Responses to Frequently Asked Questions Received During the Arboretum Bridge and Trail Project Comment Period:

Figure 1: Location of Project and Associated Neighborhood Connections

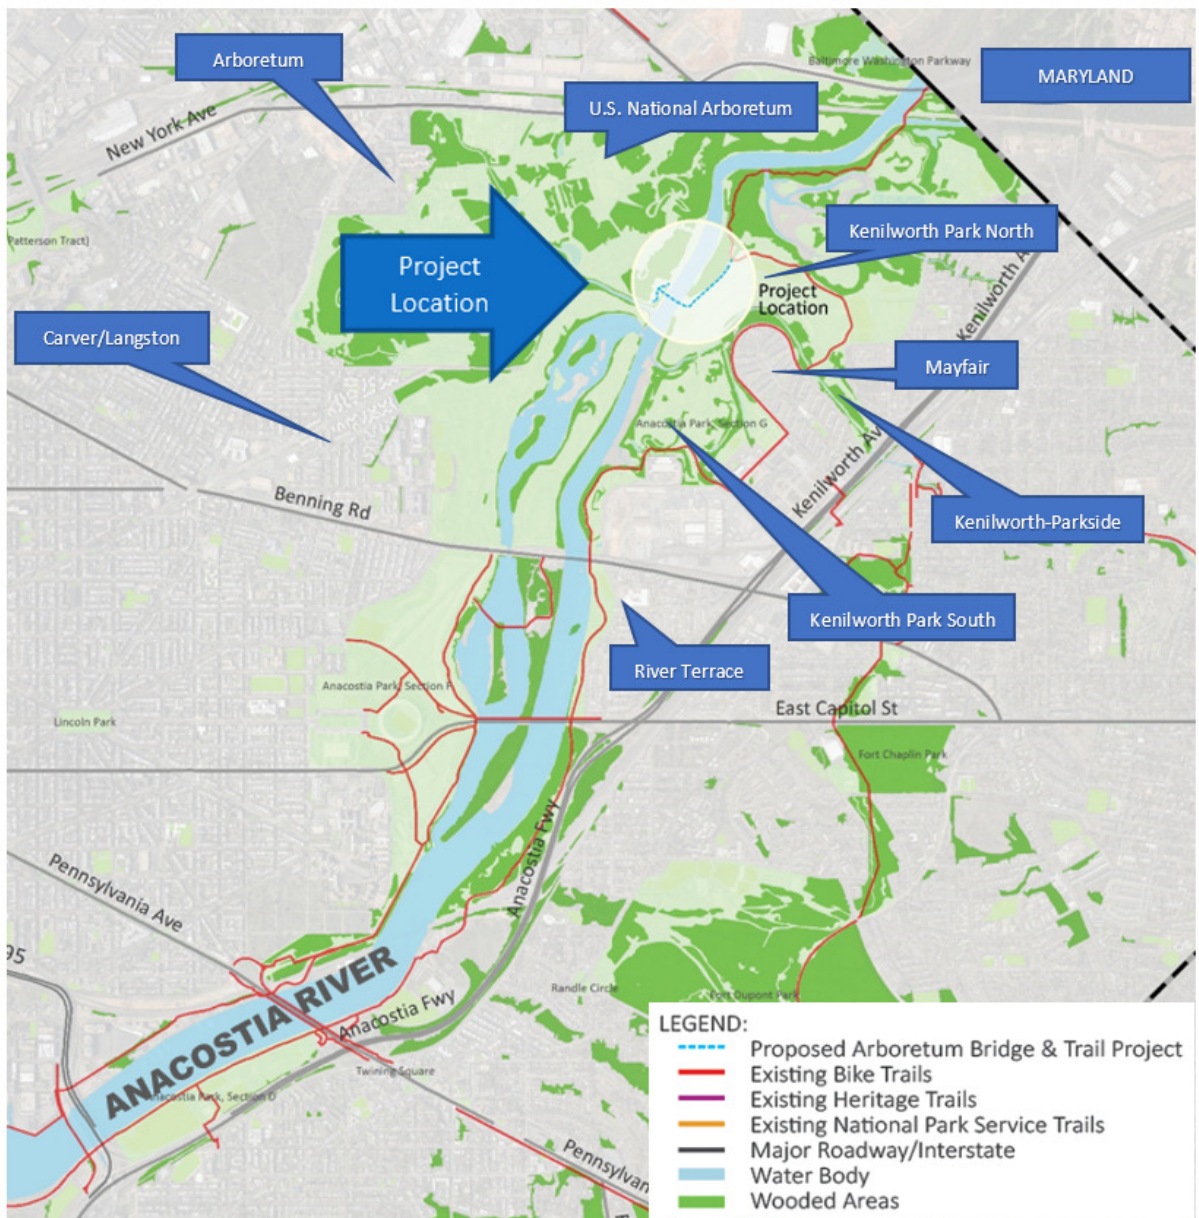
1. How was the location for this project determined, and were other locations considered?

As part of the Anacostia Waterfront Initiative, DDOT is pursuing a plan to reshape the area's transportation infrastructure into a network that improves access for residents, commuters, and visitors while also improving the area's environmental quality. DDOT's objective is to reconnect communities through the replacement of outdated and deteriorating facilities with innovative infrastructure solutions. AWI transportation goals include:

To enable DDOT to achieve these goals, the Anacostia River Trail (ART) network is being implemented sequentially, and this portion of the trail, known as Arboretum Bridge and Trail, is the next segment. The existing Benning Road crossing of the Anacostia River includes an 8-ft-wide trail, and DDOT are currently developing improved safety conditions and accessibility throughout the corridor as part of the Benning Road Transportation Improvement Project. However, the need of this project is to provide a link across the river for the neighborhoods north of Benning Road, and specifically provide direct and safe access from the eastern side of the river to the National Arboretum and western side. The Anacostia Waterfront Initiative Framework Plan from 2003 first identified the need for a pedestrian bridge at this location to connect trails on either side of the river, and the proposed alignment is in accordance with moveDC, DC's 2014 transportation master plan, which is the result of multiple planning studies that carefully vet needs and feasibility.

Additionally, the proposed location of the bridge abutments results in the least adverse impact on surrounding wetlands, contaminated land in Kenilworth Park South and potential archaeological sites (see Figure 1).
